KUCHING PORT AUTHORITY

KUCHING PORT EXPANSION PROJECT

SUMMARY REPORT

JAPAN PORT CONSULTANTS, LTD.

Fig.-1 Plan of Revetment

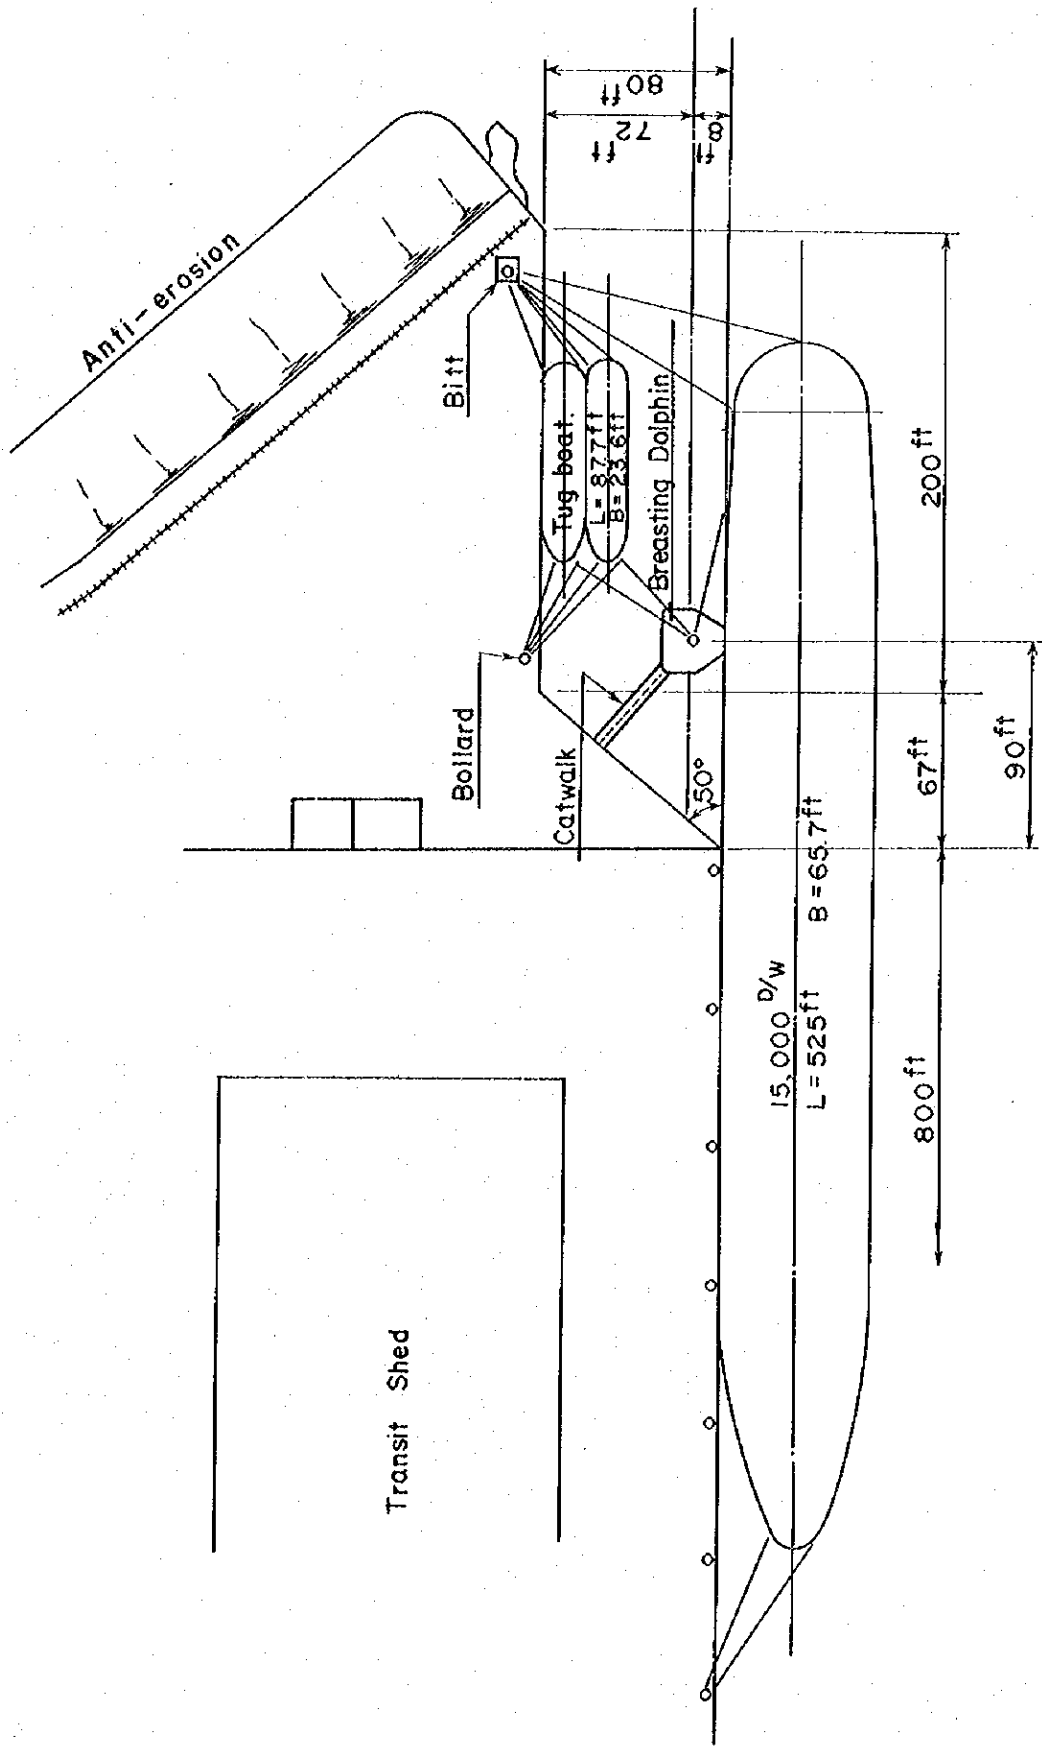
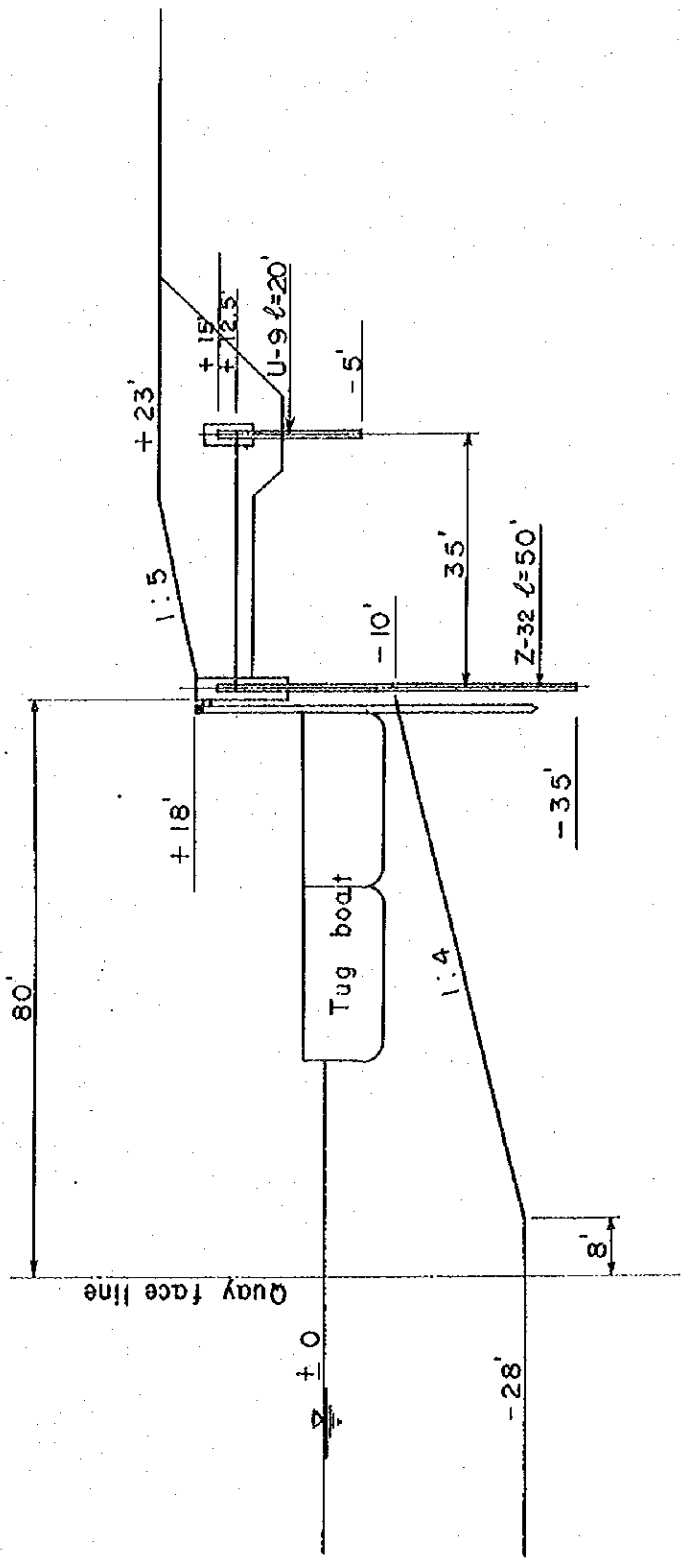
Instead, it is suggested that in place of the proposed Ramp, a steel/R.C. sheet pile wall should be constructed to close the gap to prevent under scouring and with necessary anti-erosion works/gabions and suitable landing facilities to be incorporated, for the use of tug boats and other small crafts.

As shown on Fig. 1, a breasting dolphin and catwalk are provided in the water area in front of the revetment for the berthing of a large vessel. So, the area is too small, when tugboats are moored, to leave space for other small crafts to moor and handle cargoes.

The length of the revetment is determined to be 200 ft. However, an extension of the revetment to secure berths for small crafts will affect the layout of port facilities as a whole, particularly the siting of buildings around the main gate. A more significant change resulting from the extension is the necessity of sliding the marginal river wharf upstream of the Sungai Kuap, thus affecting greatly to the future expansion works; The removal of the Pending Rocks will substantially increase the construction cost. Therefore, the revetment taking the place of the ramp shall be designed only for the tugboats, and be 200 ft long.

Note: When a large vessel takes up berth using the dolphin as shown in the Figure, the tugboat will have to find some other place to moor

In its use, the revetment has one shortcoming; That is, when a freighter of 10,000 to 15,000 dwt has taken up a berth as shown in Fig. 1 availing itself of the breasting dolphin and tying the rope to the bitt, the mooring rope will prevent tugboats from approaching and leaving the revetment. In such cases, the tugboats will have to be moored at some other places after they were used for assisting the freighter to take up the berth.

Fig. 3 Proposed Modification of Workshop and Vehicle shed

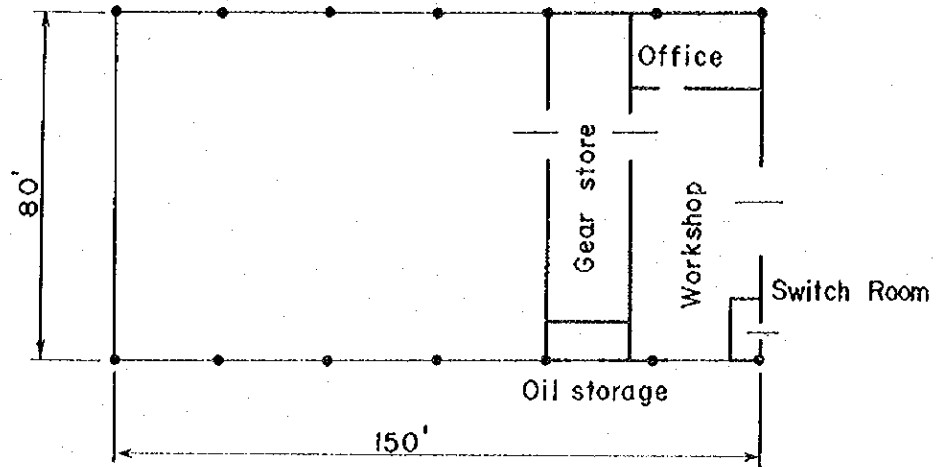
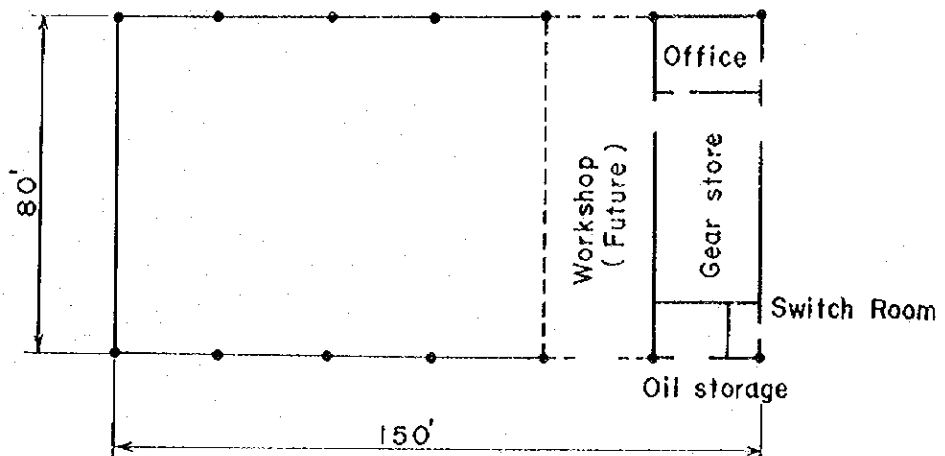
While it is essential to have a vehicle shed, gear store and oil store immediately on the commencement of the operation of the port facilities, there will be no immediate need for a workshop after the completion of the Pending Project because the existing workshop at Tanah Puteh can serve both Tanah Puteh and Pending Operations. The Consultants are, therefore, requested to draw the building plans in such a way that the construction of the vehicle shed and the workshop can be conveniently carried out at two different stages.

The plan for the workshop and vehicle shed shall be altered as shown in Fig. 3 so that the workshop may be constructed at a different stage in the future.

Fig - 4. Test Pieces Used in Corrosion Test

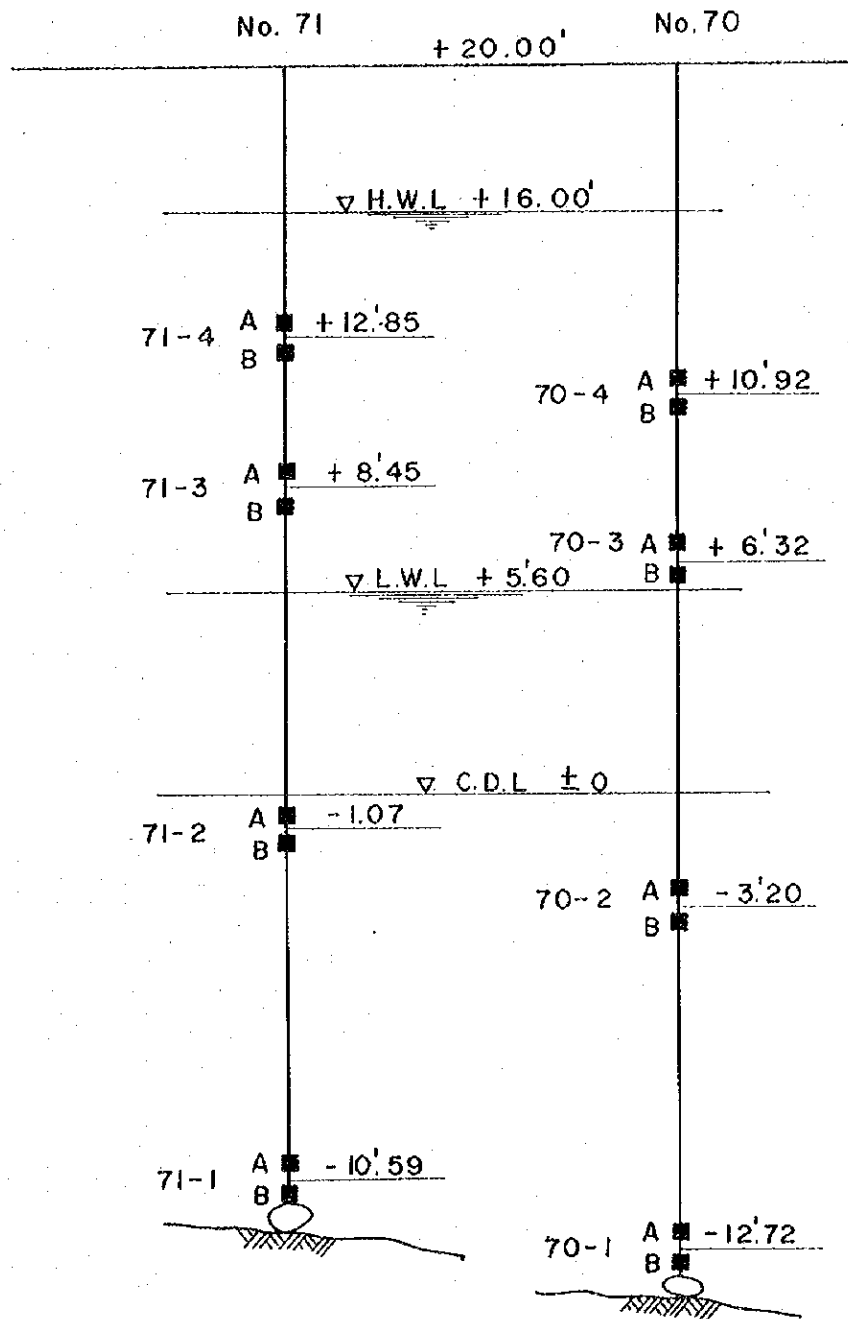
The Consultants set out in this paragraph various reasons why steel sheet pile type of wharf is preferred and recommended and also quote the cost per foot for three types of wharf. It is noted that the difference of the total costs between the steel sheet pile type and the gravity type is only \$256,000; and the difference between the steel sheet pile type and the shore bridge type is \$440,000. These differences are not considered great in view of the magnitude of the Project. Unfortunately it appears that the cost of maintenance, which is an important factor, for each type of wharf does not seem to have been taken into due consideration by the Consultants in arriving at their recommendation. It is also necessary to take into account the local facilities for repairing or maintaining the wharf. The Consultants should carry out comparative cost studies of the materials to be used i.e. between cement and steel structures and such studies should take into consideration such factors as the use of as much locally-produced materials as possible e.g. cement. The State Government should have various options clearly worked out by the Consultants before committing on any choice of design. Furthermore the Report indicates on page 79 that the corrosive effect of the water in the Pending Area is generally 20% higher than that experienced in Japan but the method for cathodic protection and its effectiveness have not been fully explained. It would seem also that tests on the test pieces submerged at Pending for two months incomplete.

As shown on Fig. 4, four each of test pieces A and B, which had previously been measured, were submerged at two places. Of the test pieces, the type A were electrically connected each other through the electric cable used for the installation of these pieces to measure corrosion including that caused by the oxygen concentration cell in the direction of the depth of the water. By measuring the corrosion of the type A, the rate of corrosion of steel materials such as steel sheet pipe piles can be obtained, which are submerged into water in the vertical direction. The type B, on the other hand, will reveal the rate of corrosion of steel materials installed horizontally at depths indicated by these test pieces.

Fig.-6 Comparison of Water Level.

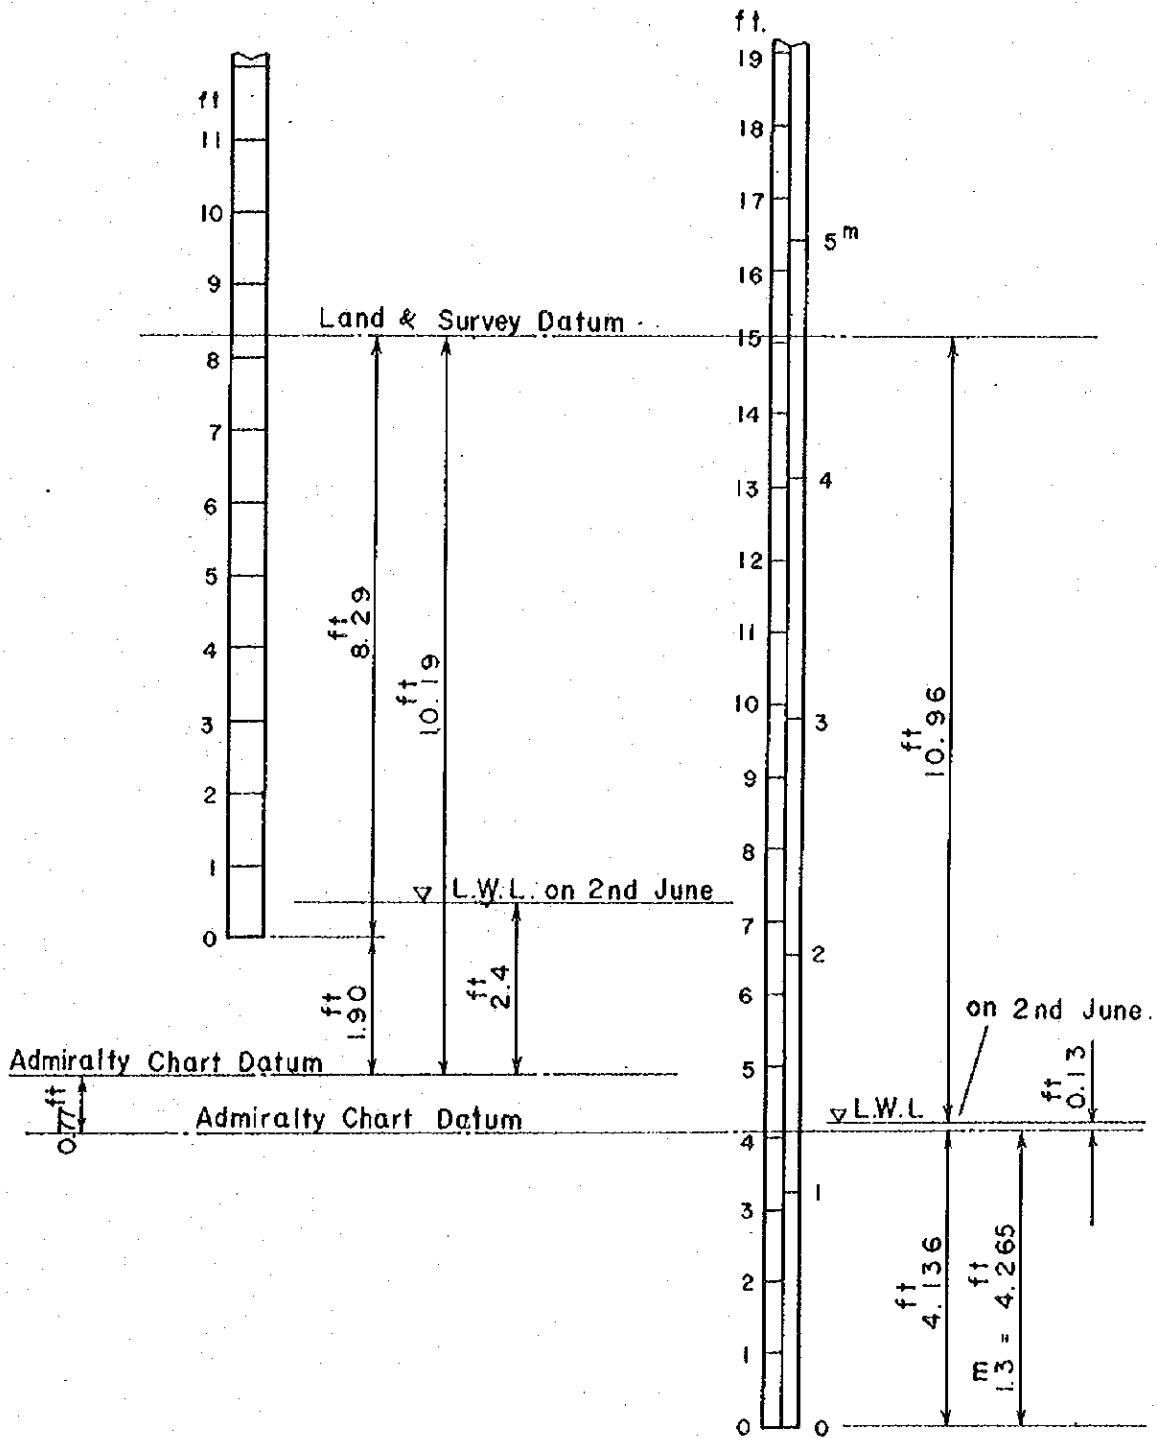
measurement taken from the Water Level Recorder at Pending show that the lowest water level on 2nd June 1969 as 1.3 meter (4.27 feet). The zero point of the recorder is set at 4.83 feet below the A.C.D. i.e. this point is - 4.83 A.C.D. The lowest recorded level is therefore 4.27 feet above the zero point i.e. $- 4.83 + 4.27 = 0.56$ A.C.D. (Please see Appendix attached).

Further clarification from the Consultants will be appreciated.

The low water level on the 2nd June 1969, therefore, was 0.13ft above the chart datum (See Fig.6).

Fig.-7: Suggested Location of Workyard

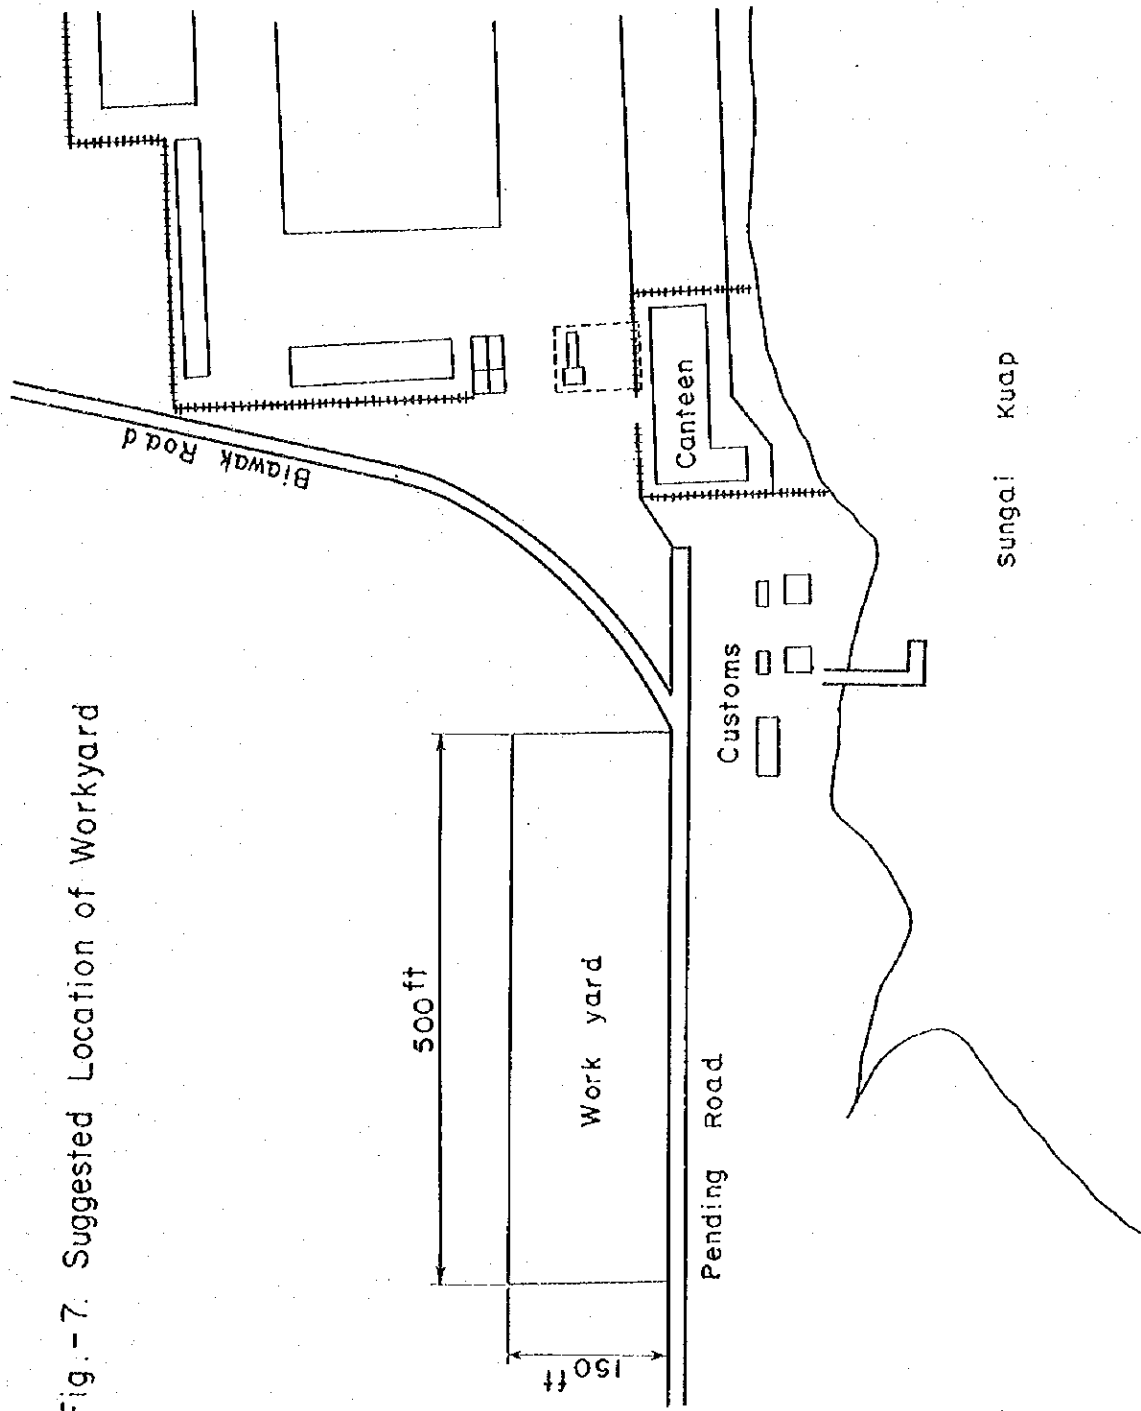
v) It has been considered appropriate until the submission of the Initial Interim Report to provide the land marked "turf" in the general layout for the Contractor's workyard. However, as it has been found necessary to remove the house refuse from this area, it would seem better also for the efficiency of the works to designate an area outside the fence along the Pending Road for the Contractor's workyard. This area will have to be reclaimed to make it available for the workyard. (See Fig. 7).

The area shown in Fig. 7 is considered suitable for the workyard so that it may be designated in the specifications as the yard to be used by the Contractor. As to the selection of the yard, however, the common practice is to leave the whole thing with the discretion of the Contractor. We would appreciate if you could, as a matter of urgency, to provide us with your opinions on items iv) and v).
